E/ECE/324
E/ECE/TRANS/505 } Rev.1/Add.25/Amend.3

Addendum 25: Regulation No. 26

Amendment 3

UNIFORM PROVISIONS CONCERNING THE APPROVAL OF VEHICLES WITH REGARD TO THEIR EXTERNAL PROJECTIONS

Figure 1 "

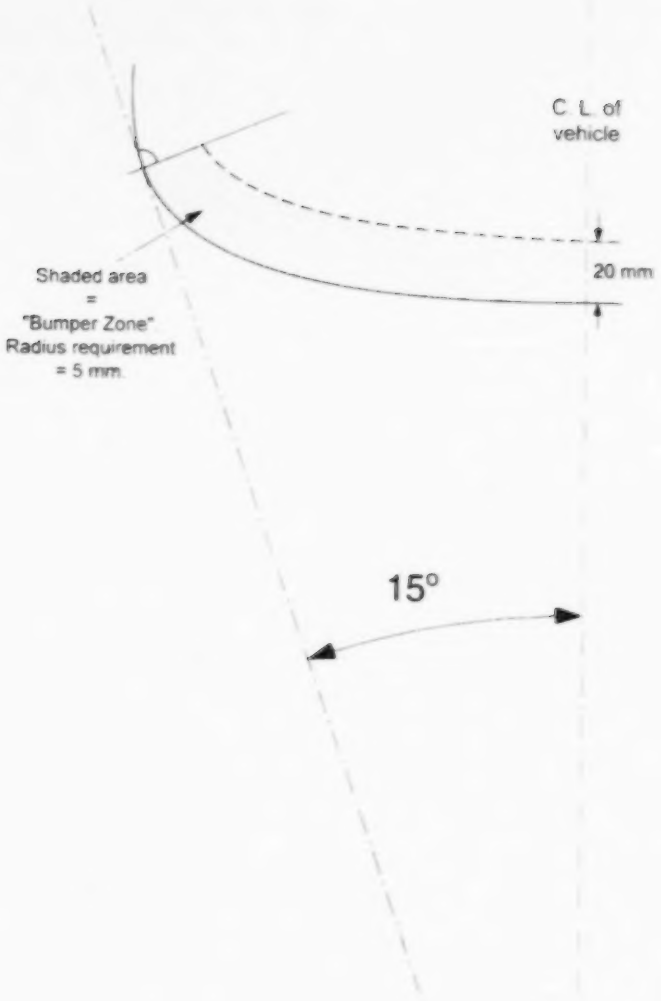
Paragraph 6.5.2., amend to read (including a new figure 1):

"6.5.2. If the line of the bumper which corresponds to the outline contour of the car vertical projection is on a rigid surface, that surface shall have a minimum radius of curvature of 5 mm at all its points lying from the contour line to 20 mm inward, and a minimum radius of curvature of 2.5 mm in all other cases. This provision applies to that part of the zone lying from the contour line to 20 mm inward which is situated between and in front (or rear in case of the rear bumper) of tangential points with the contour line of two vertical planes each forming with the longitudinal plane of symmetry of the vehicle an angle of 15° (see fig. 1).
